CALIFORNIA COASTAL COMMISSION

STAFF REPORT: APPEALDE NOVO HEARING

APPEAL NO.: **A-1-CRC-02-150**

PROJECT DESCRIPTION: **Construction of a 2,850-square-foot, 1- to 2-story, 13- to 25-foot-high, single-family residence with attached garage.**

Figure 4. Map of Kraft property (modified from TE, 2001). Note the location of the proposed building area (hatched area) and TE (2001) backhoe exploration pit #1, BGC exploration hole BGC-1, and cross section A-A' (Figure 5). Scale 1" = ~30'.

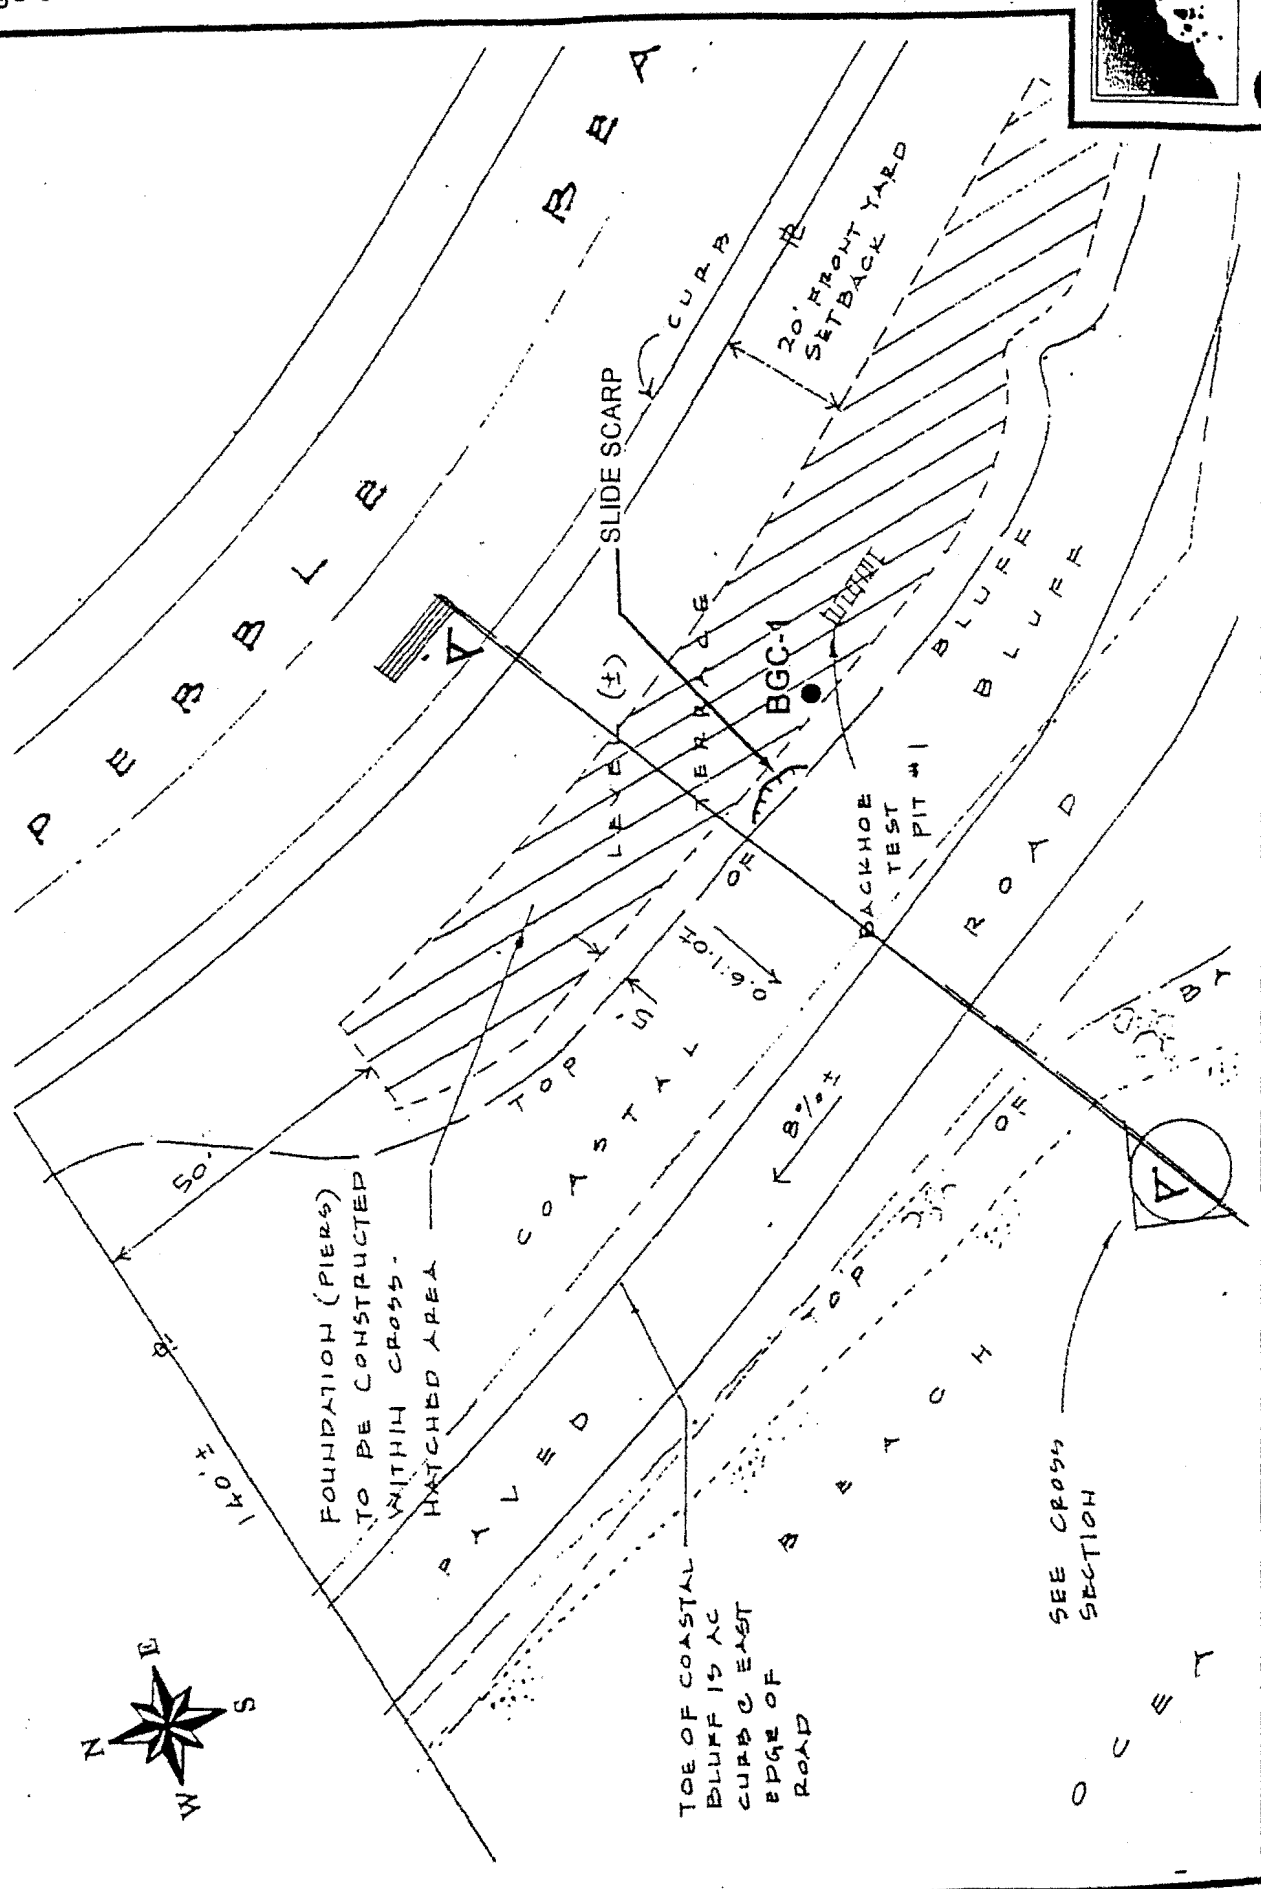
Of greater relevance is the issue of improperly drained surface water runoff over the edge of the terrace. The small slide scarp along the bluff edge (Figure 4) is indicative of a failure caused by misdirected runoff across an over-steepened road cutbank (see REC 5).

Existing site-specific hazards and (in parentheses) associated risks of foundation damage exceeding conventional tolerances at the homesite, if the home is built on a conventional shallow foundation with the bluff-top setback shown on Figure 4 and the hazard goes unmitigated—are:

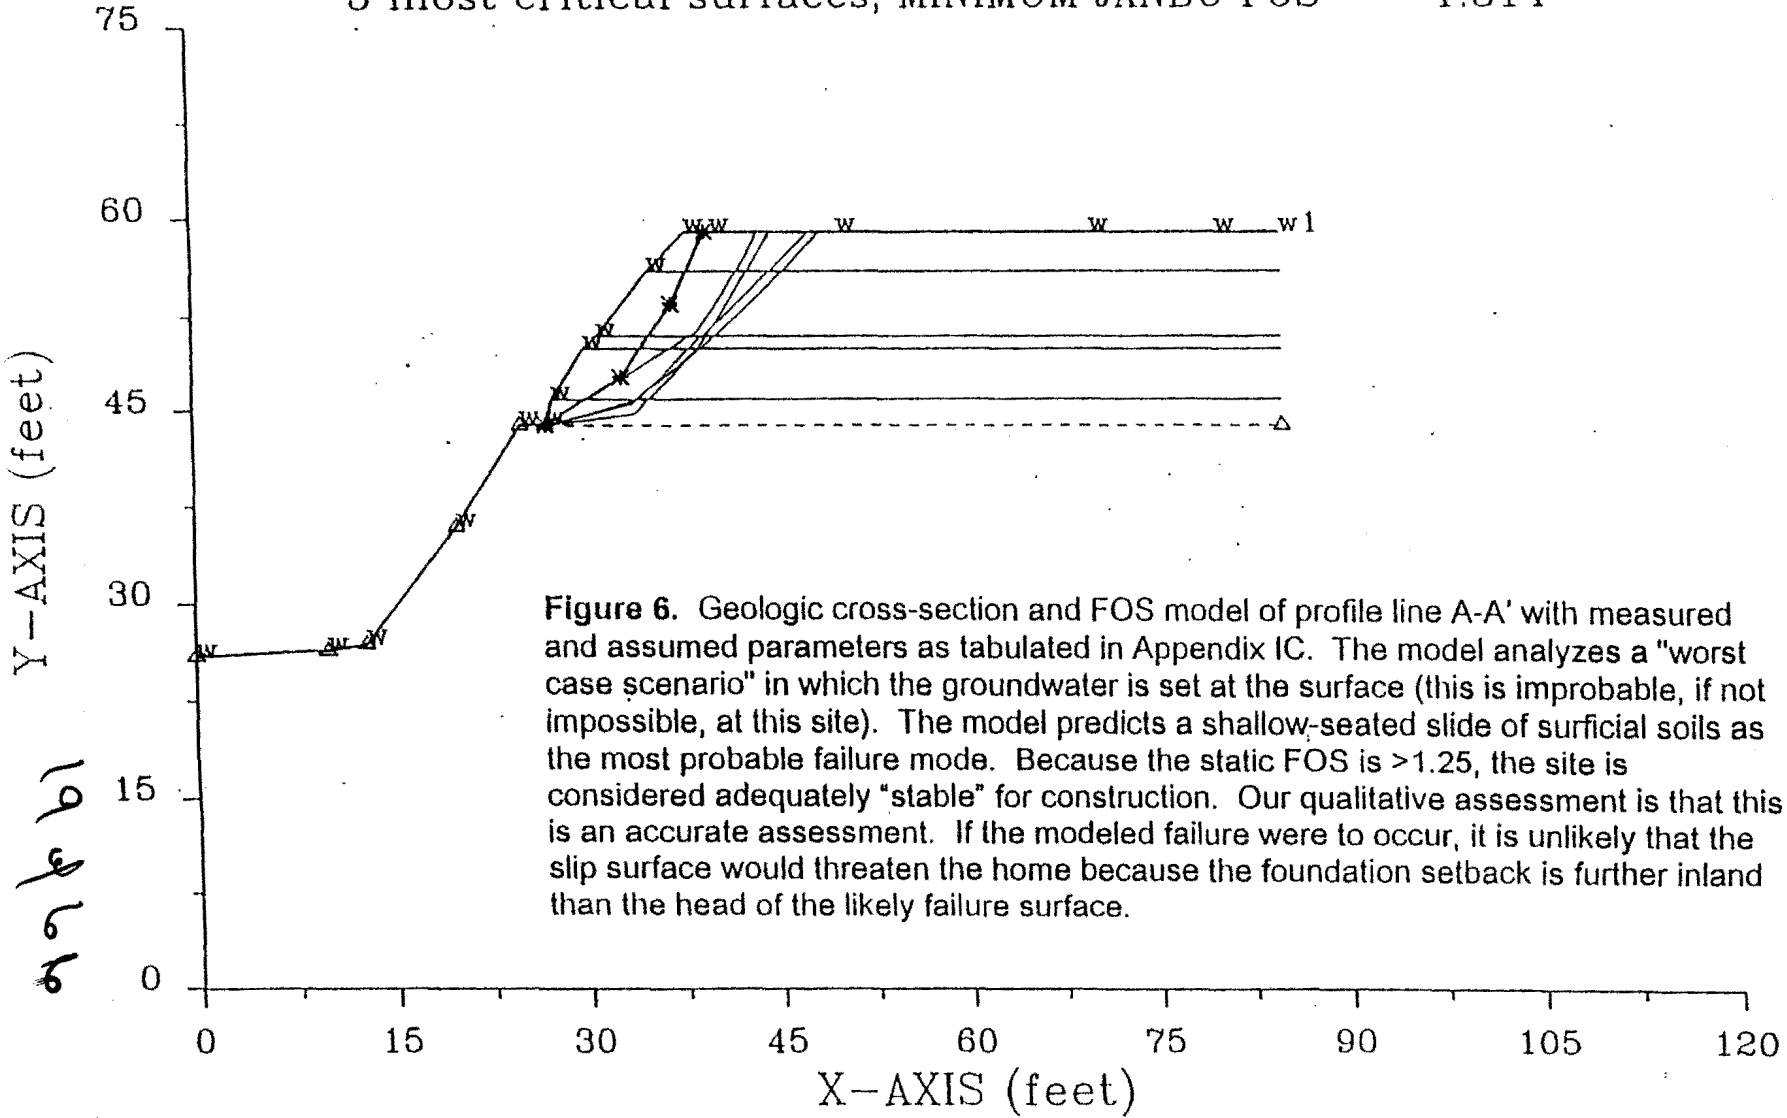
- 1, the most probable slope failure mode is shallow landsliding of weathered surficial soils on the face of the bluff (see Figure 6);
- 2, on the critical profile, $FOS_s = 1.31$ and the failure sole intersects the ground surface ~2 feet east of the break-in-slope, well west of the house footprint; and
- 3, on the profile line, $FOS_d = 1.11$, extending ~10 ft east of the break-in-slope, which would lie within the house footprint (Figure 7).

Figure 7. Geologic cross-section and FOS model of profile line A-A' with a seismic load (coefficient, 0.15). Dark line is the most probable failure surface. We held all other parameters constant (see values listed on Figure 6).

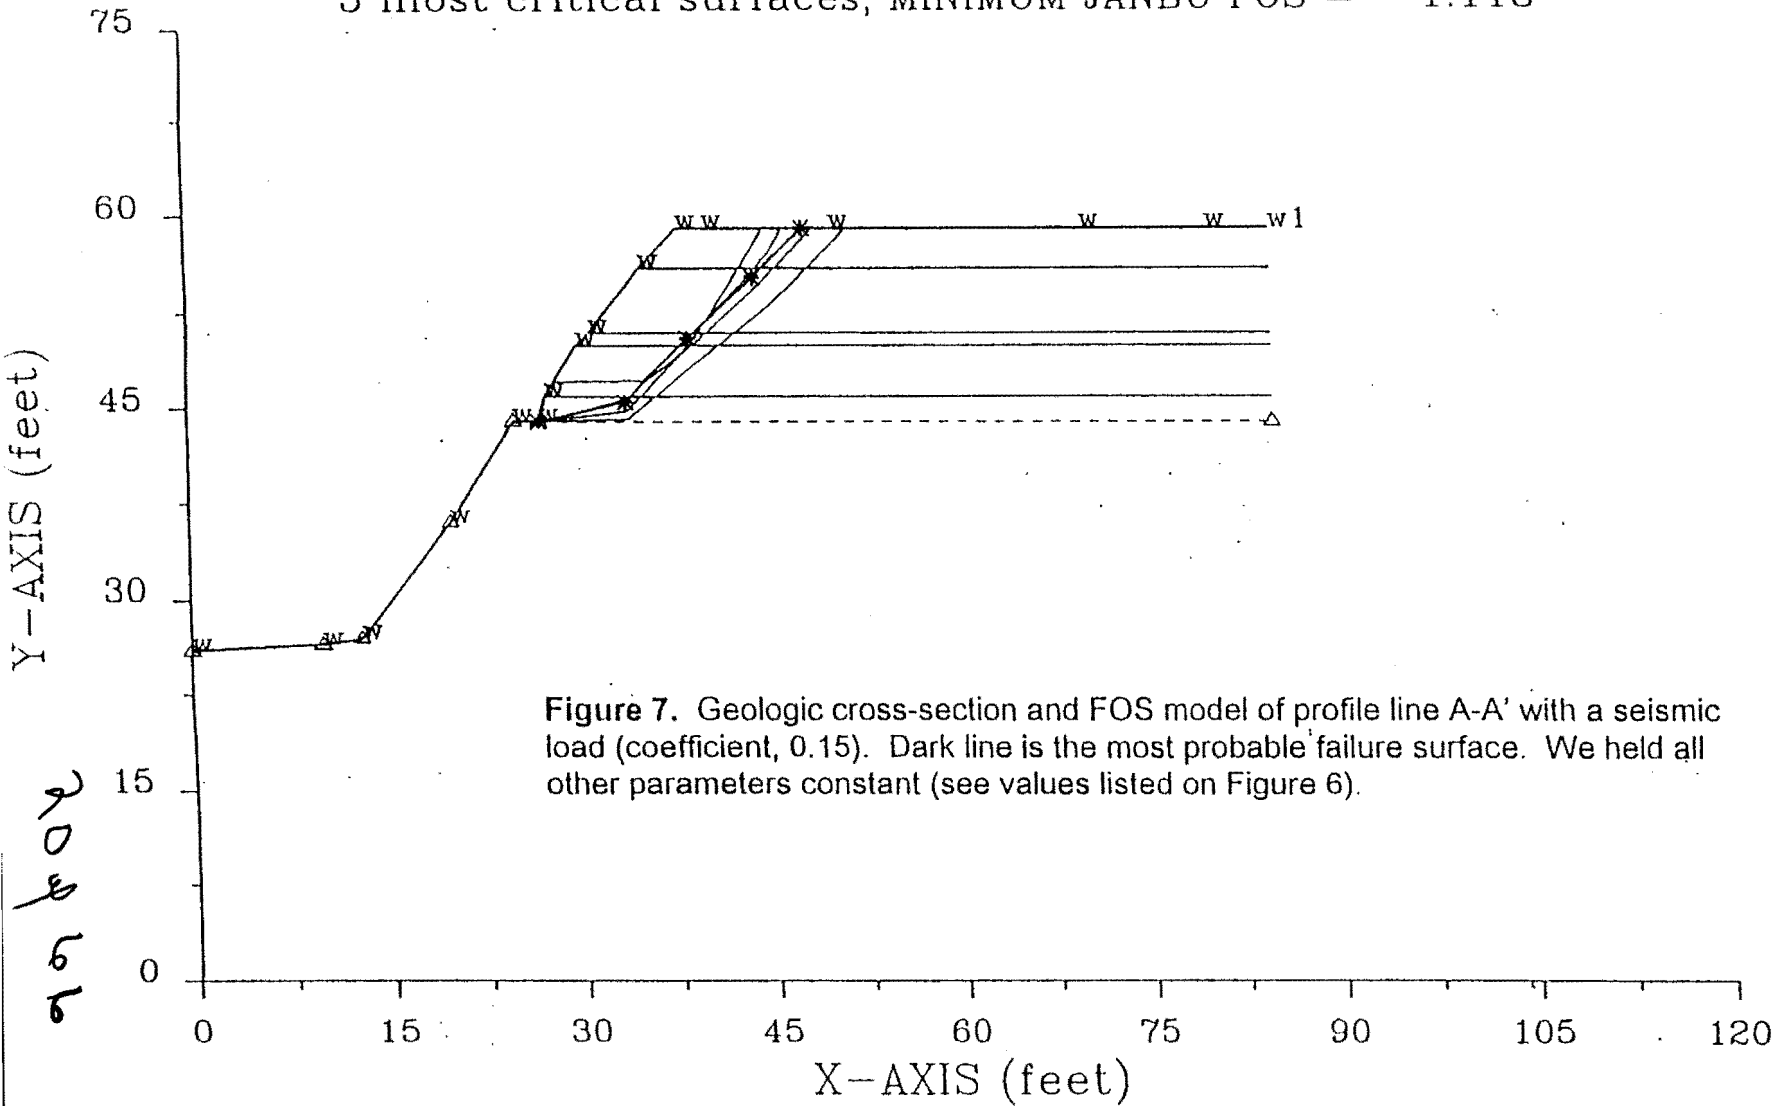
3, on the profile line, $FOS_d = 1.11$, extending ~10 ft east of the break-in-slope, which would lie within the house footprint (Figure 7).

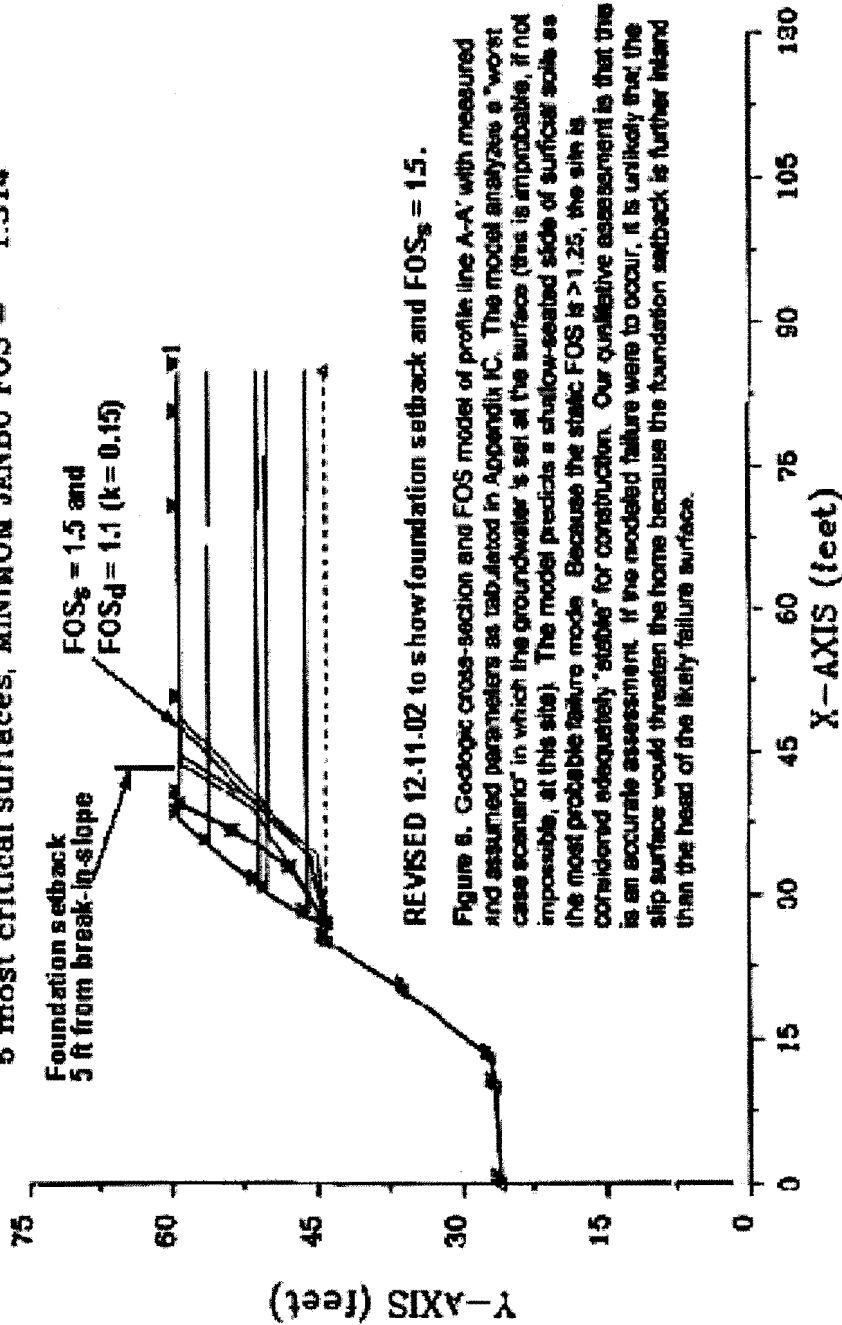
Here, attached, is a figure that shows where on the critical profile of the lot the foundation setback plots and the FOSs = 1.5 failure plane is.

As I have pointed out, it is not necessary to set back behind the FOSs 1.5 line because the home will rest on a pier foundation embedded into rock.

PIER CONFIGURATIONS REVISED PER R.E. BUSCH FACTOR OF SAFETY / SLIP SURFACE ANALYSIS. REVISED 1/23/03

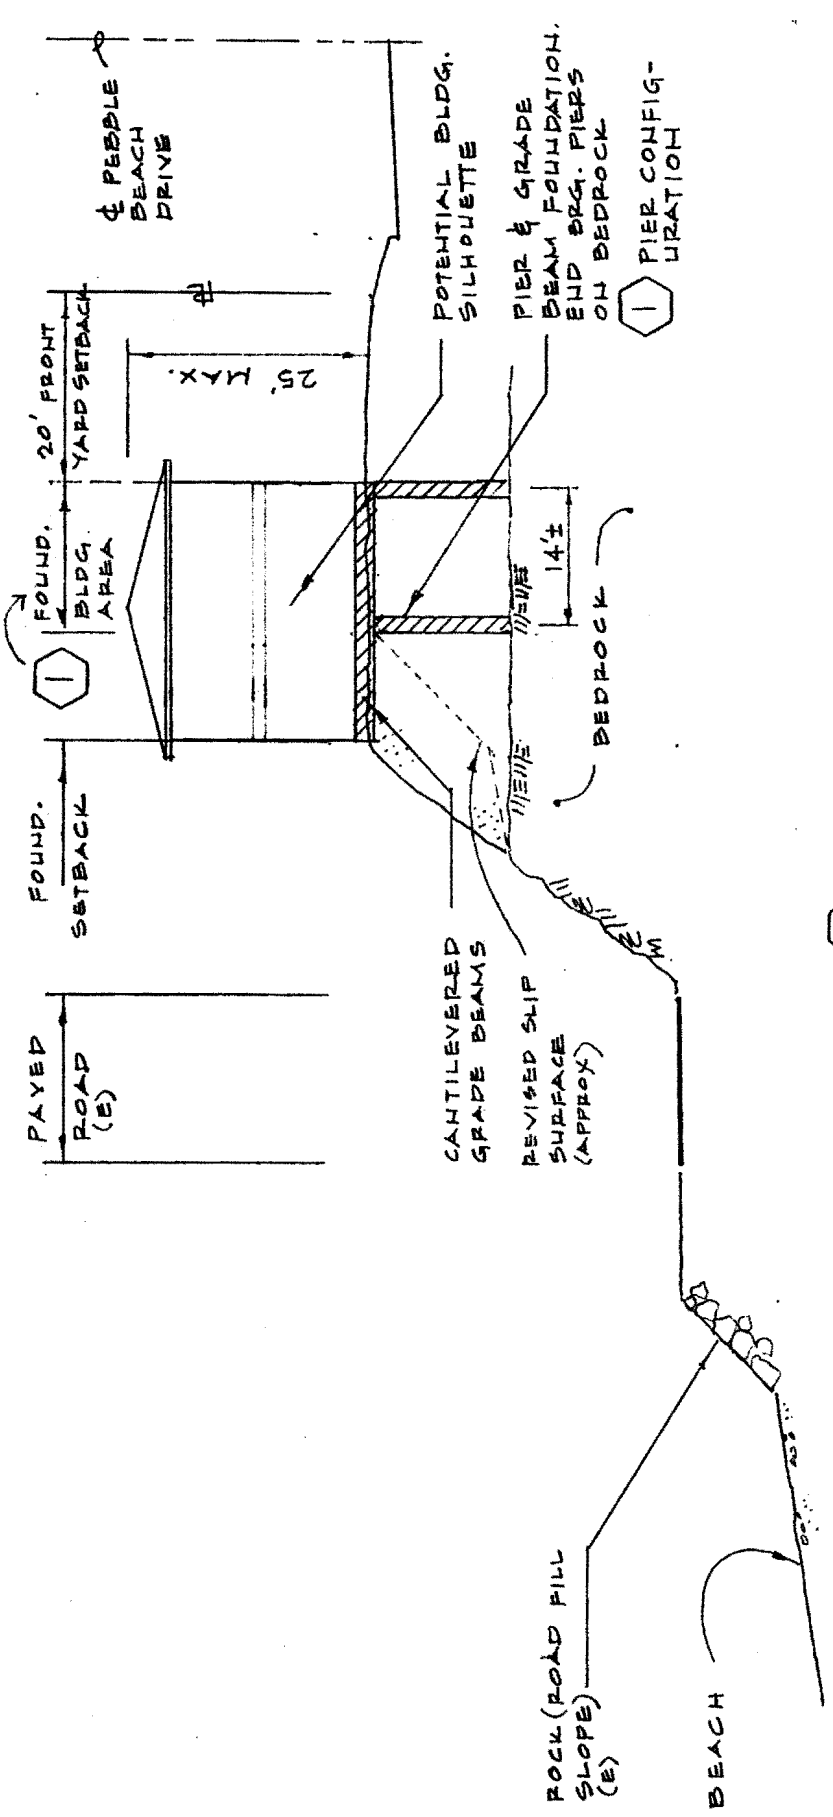
Please find attached my cross section showing the revised foundation configuration for the Beth Forest Trust proposed residential development of APN 118-300-03 in Crescent City. As you know, the foundation will be constructed of reinforced concrete piers and grade beams. The proposed piers have been moved further inland to clear the revised critical slip plane surface (FOS=1.5) as determined by Busch Geotechnical.

Attached are my sample calculations using a pier spacing of 14 feet and a 10 foot grade beam cantilever transverse to the slope. Since the piers must be embedded to bedrock, the skin friction on the most inland piers can easily resist the uplift forces resulting from the cantilever.

It is therefor my conclusion that the proposed foundation system can be constructed to support the residence provided the design is in compliance with the Uniform Building Code, recommendations as set forth in the Busch Geotechnical Report and sound engineering practice.
